To: T10 Technical Committee
From: Rob Elliott, HP (elliott@hp.com)
Date: 9 December 2004
Subject: 04-370r2 SAS-1.1 Merge IT and IR with XT and XR

Overview

Suggested changes

Figure 12 — Deriving a receiver device jitter tolerance eye mask at IR, CR, or XR

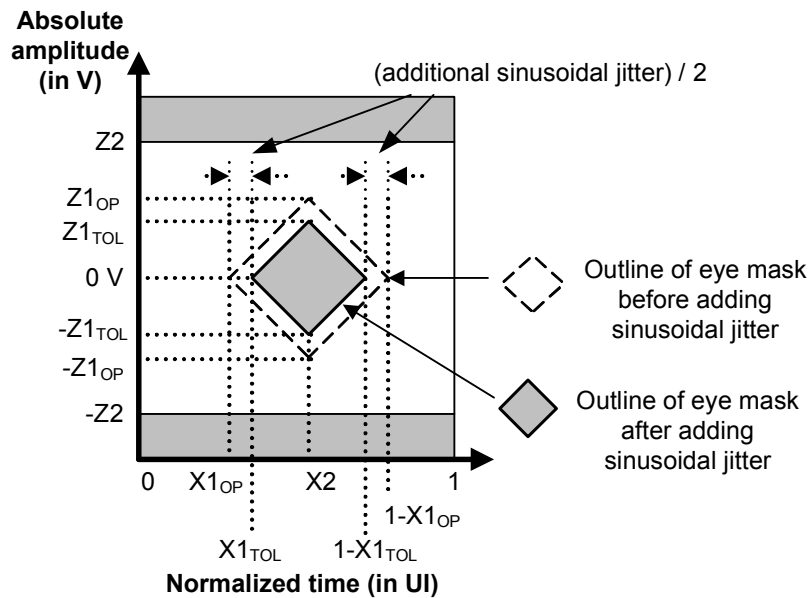
Figure 12 describes the ~~receive tolerance eye masks at IR, CR, and XR and eye mask used to test the jitter tolerance of the receiver device at IR and CR.~~ Figure 12 shall be constructed using the X2 and Z2 values given in table 4. X1_{OP} shall be half the value for total jitter in table 8 and X1_{TOL} shall be half the value for total jitter in table 10, for applied sinusoidal jitter frequencies above ((bit rate) / 1 667).
